A1 Birtley to Coal House

7.6 Statement of Common Ground: Historic England

STATEMENT OF COMMON GROUND: HISTORIC ENGLAND

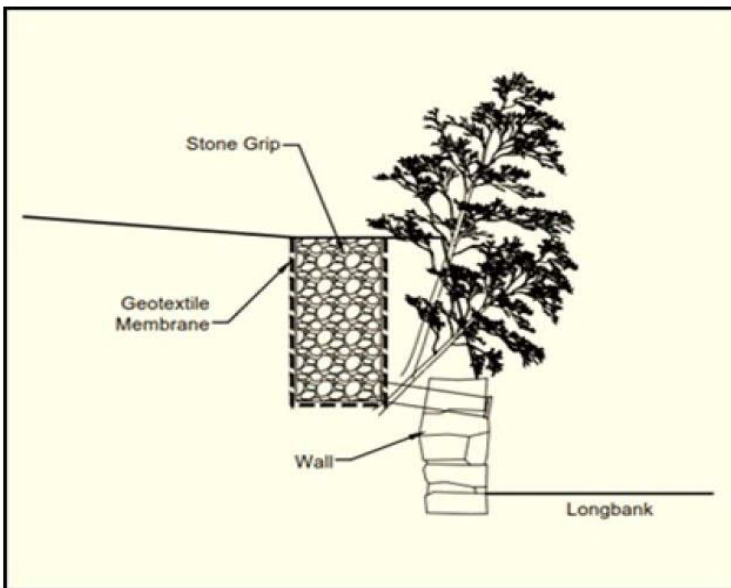
ITEM	SUBJECT	ACTION	DUE
	<p>Drainage grip behind the retaining wall</p> <p>The sketch detailing the drainage grip behind the retaining wall provided by WSP via email on 15 May 2020 was discussed.</p> <p>3 ■ questioned how much water would be expected to travel through and the expected associated damage to the wall. ■ discussed that the responsibility for future maintenance of the drainage would be Highways England.</p> <p>Action: ■ to clarify with the drainage engineers the level of water that would be expected to go through the wall and what impact the water would have on the wall.</p>	■	01 June 2020
	<p>Outline CEMP [CH2]</p> <p>4 ■ A discussed the wording of “substantially in accordance with” in [CH2] of Table 3-1 REAC the Outline CEMP. It was discussed that Historic England will be consulted on the final WSI and any should Historic England have any concerns that these would be raised with the Secretary of State (SoS). She further discussed that the Scheme will need to demonstrate that any changes to the documentation i.e. in the final CEMP and WSI, do not cause any worsening of effects and that Highways England has an “evaluation of change” process that ensures this is the case. ■ discussed that this wording would remain unchanged in the Outline CEMP being submitted at Deadline 6 (19 May 2020).</p> <p>Action: ■ to seek guidance from Historic England’s legal advisor on this wording.</p>	■	01 June 2020

I have also provided below the likely detail of the drainage grip behind the retaining wall for your information / further discussion.
